**COUNTY OF SAN MATEO
PLANNING AND BUILDING DEPARTMENT**

SUBJECT: EXECUTIVE SUMMARY: Consideration of a Design Review Permit, Grading Permit, and Certificate of Compliance (Type B) to construct a new 4,080 sq. ft. single-family residence (3,508 sq. ft. house with an attached 572 sq. ft. garage) on a 28,820 sq. ft. parcel, to be legalized, located at 180 Winding Way in the unincorporated Devonshire area of San Mateo County. The project involves removal of twelve significant trees and earthwork in the amount of 638 cubic yards.

County File Number: PLN 2015-00451 (Gomez/Lubin)

SUBJECT: Consideration of a Design Review Permit, Grading Permit, and Certificate of Compliance (Type B) to construct a new 4,080 sq. ft. single-family residence (3,508 sq. ft. house with an attached 572 sq. ft. garage) on a 28,820 sq. ft. parcel, to be legalized, located at 180 Winding Way in the unincorporated Devonshire area of San Mateo County. The project involves removal of twelve significant trees and earthwork in the amount of 638 cubic yards.

2 NORTH (FRONT) GARAGE ELEVATION Scale: 1/4" = 1'-0"

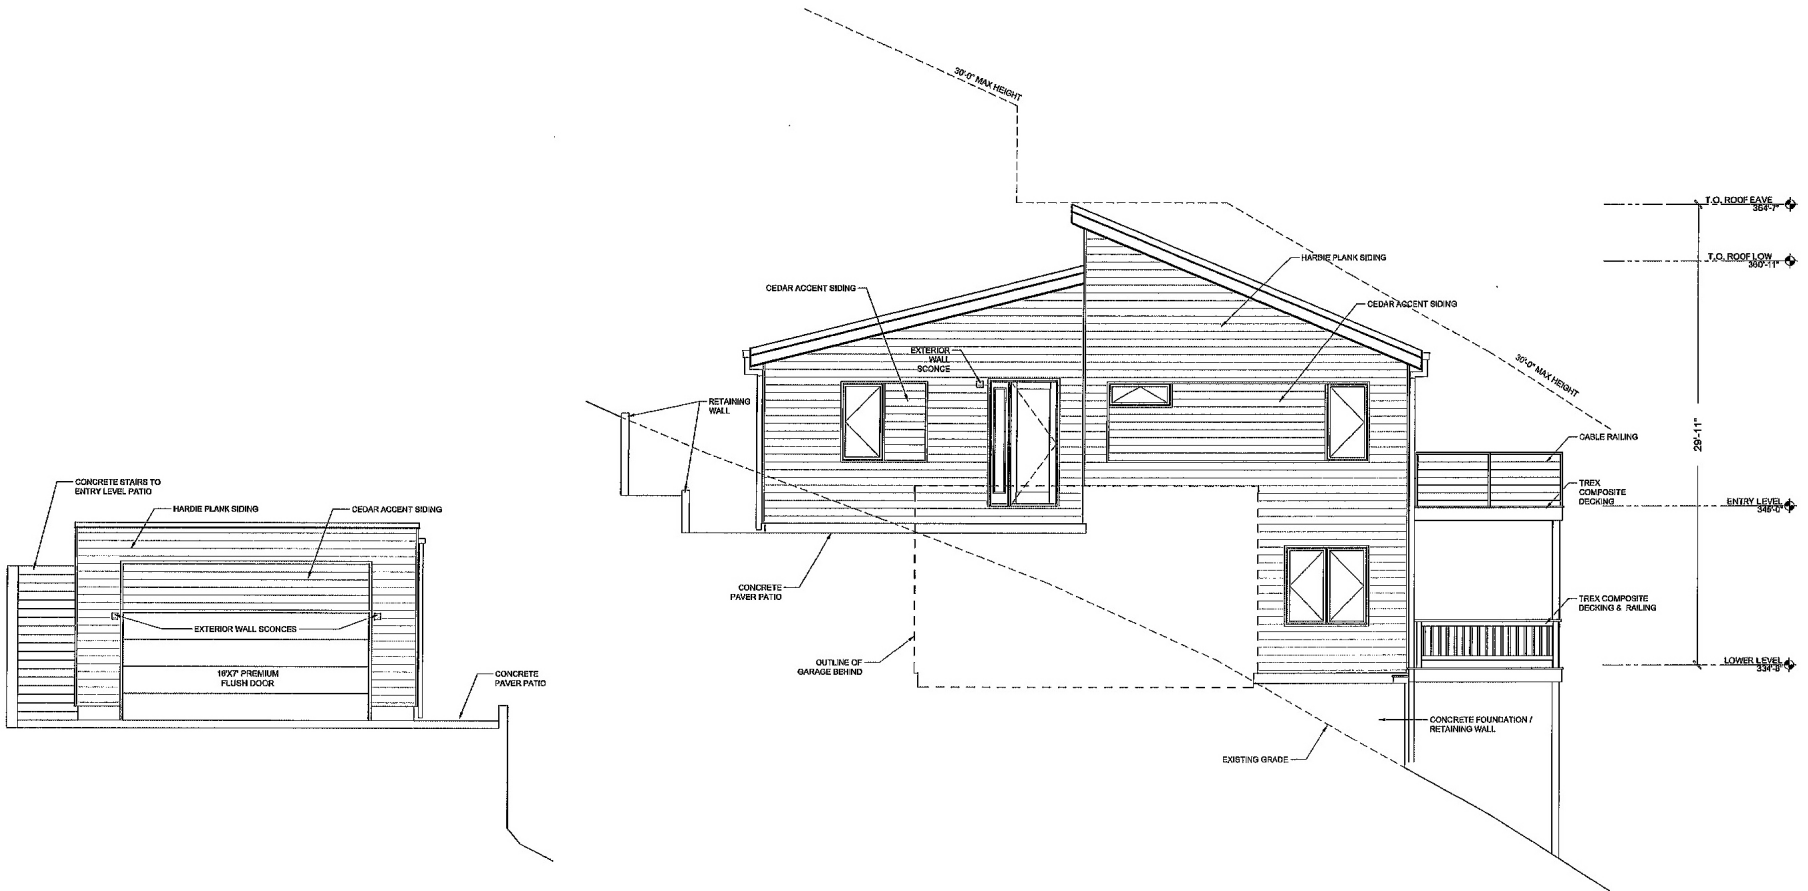
The color of the garage door was initially proposed to be white. The BDRC expressed concern over the garage color since it was not compliant with the standards and is the most visible part of the residence from the street.

The applicant changed the garage door color to “bronze,” a shade of grey, to meet the BDRC’s requirement. Condition No. 3 has been added to record this change.

5. The garage door color shall be changed to "Bronze," a shade of grey, in order to more closely match the window frames and doors.
6. Prior to any grading or construction activity on the project site, the property owner shall implement the following tree protection plan:
